CITY OF MADISON
CITY ENGINEERING DIVISION
DEPARTMENT OF PUBLIC WORKS
PLAN OF PROPOSED IMPROVEMENT

PFLAUM ROAD ASSESSMENT
DISTRICT - 2025

CITY PROJECT NO. 14781
CONTRACT NO. 8747

1. REV#1 - ISSUED 8/3/26
2. REV#2 - SHEETS U6-U8, U11-U13, U17, U18, W6, W8, W14, W16, W17, & W24 UPDATED.

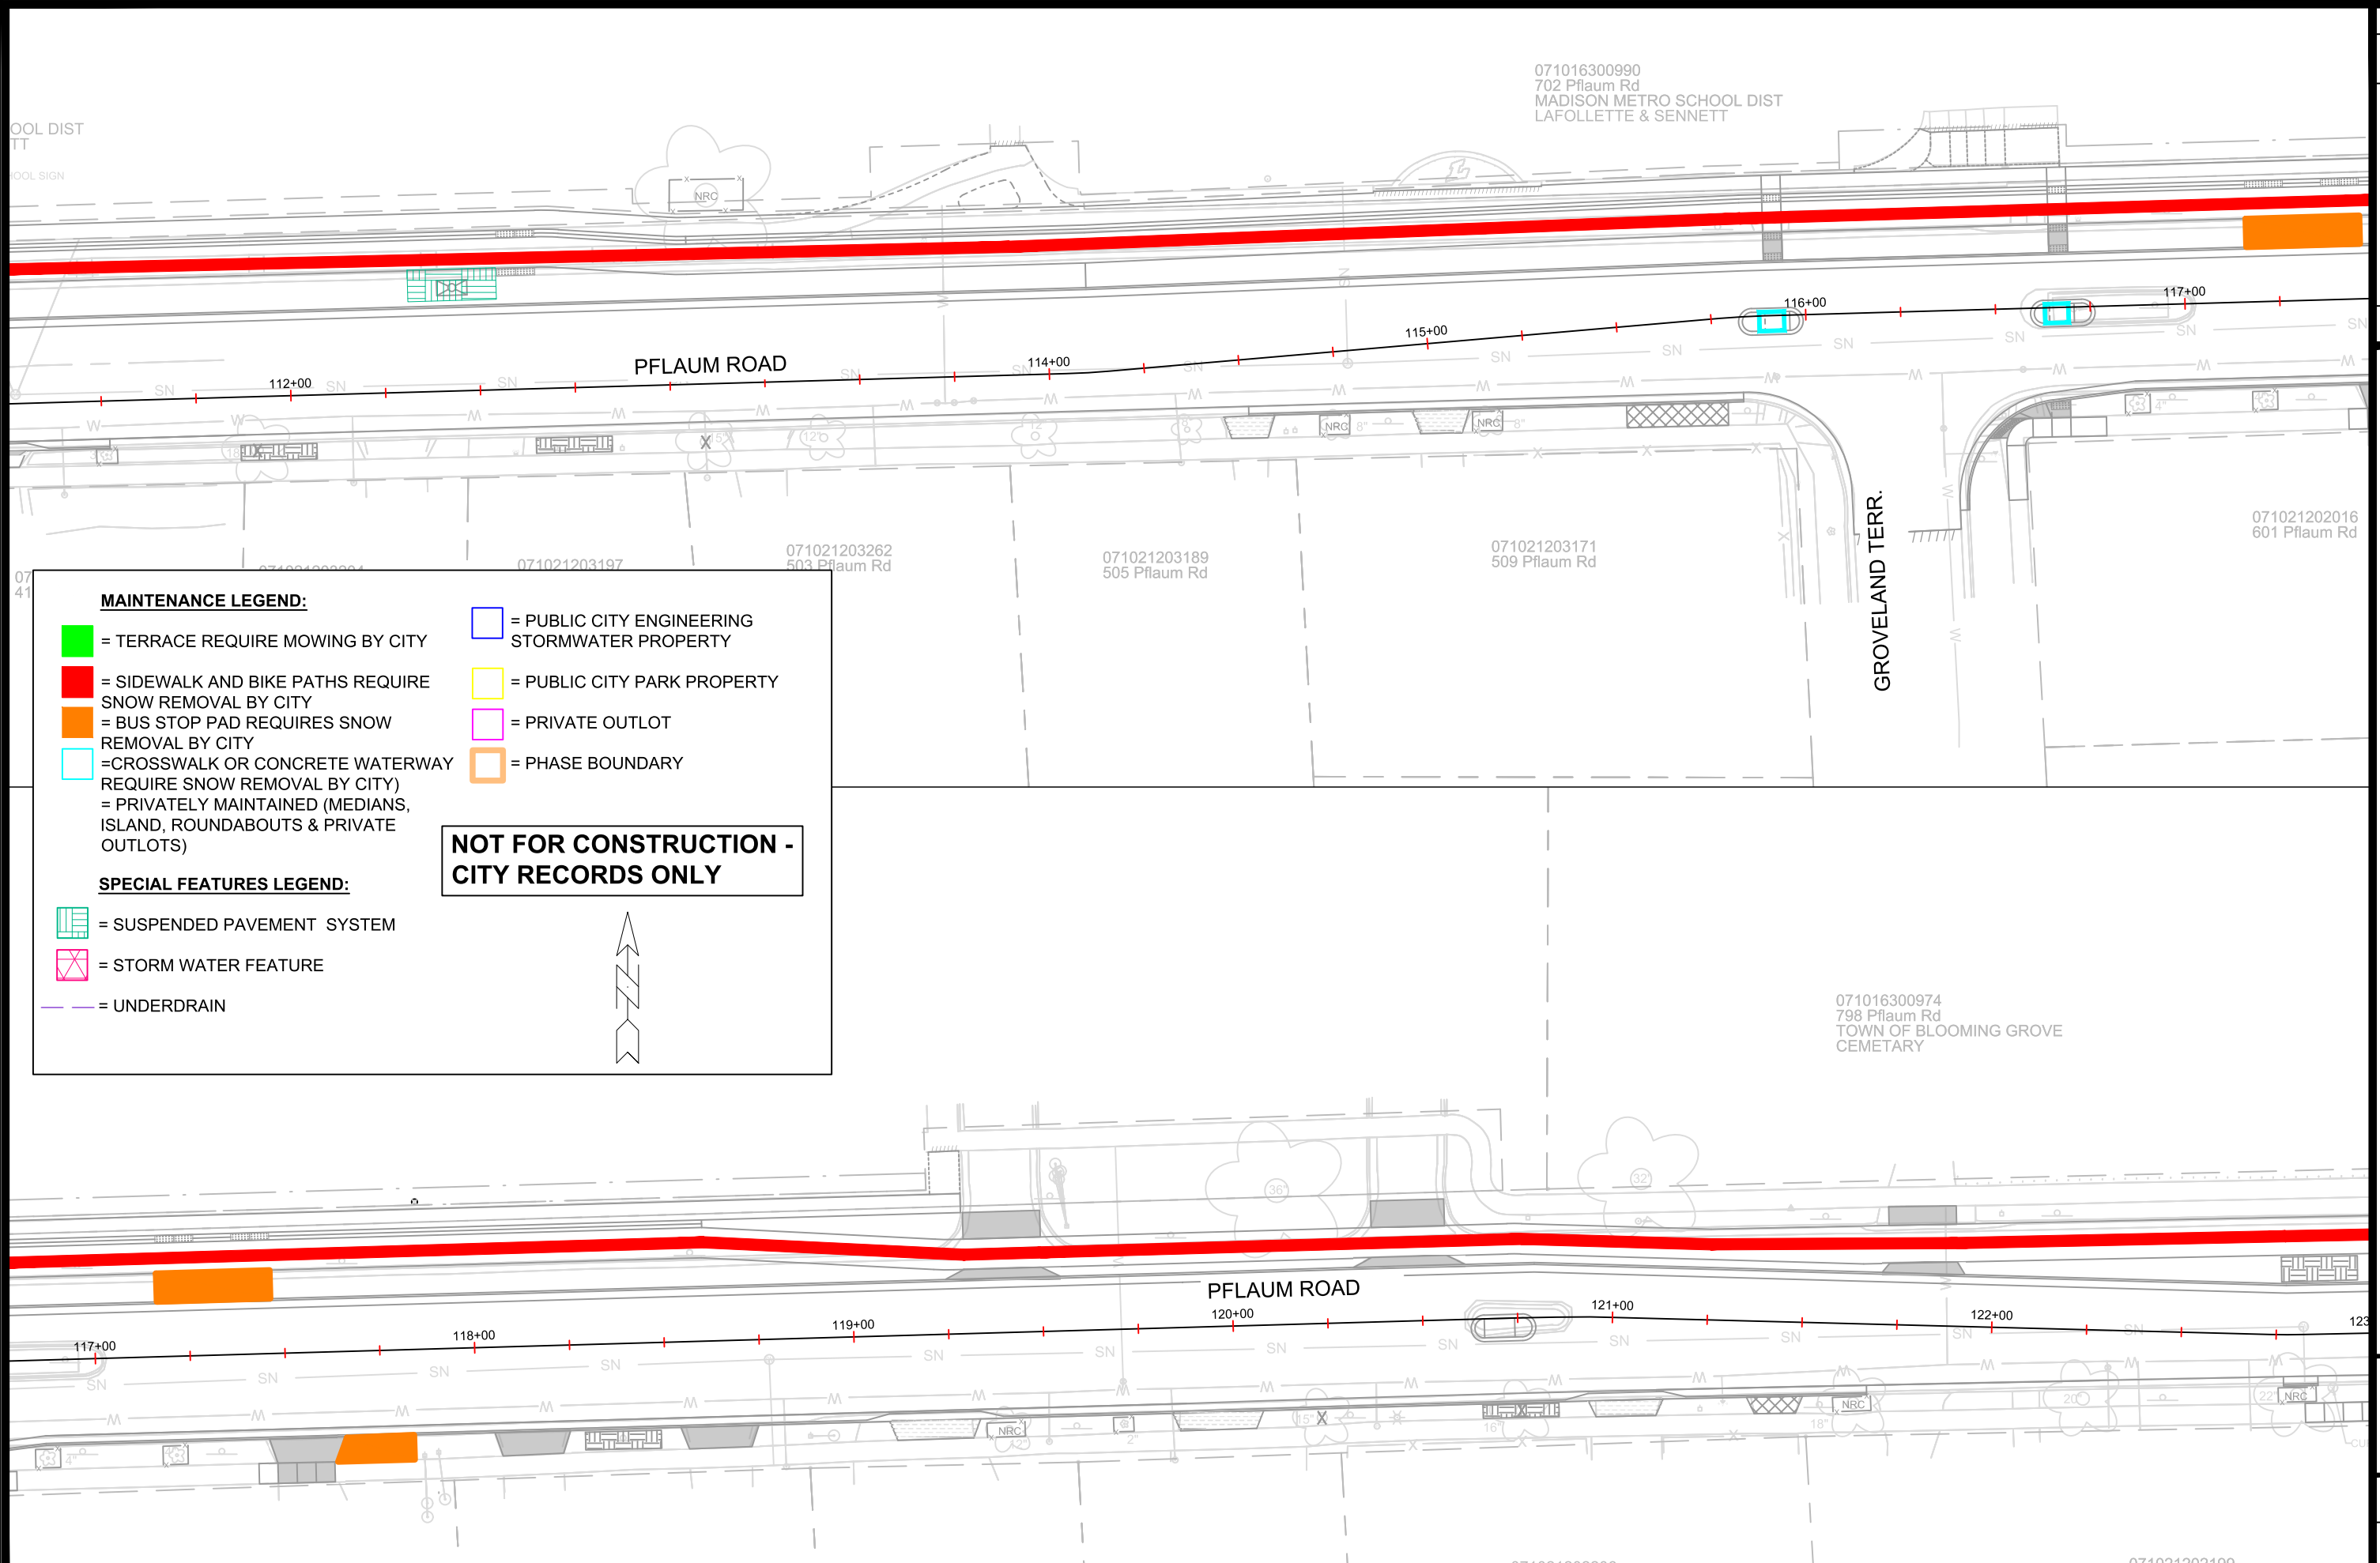
REV#1 - IO - 7/22/26
1. BIKE PATH & RAMP MODIFIED.
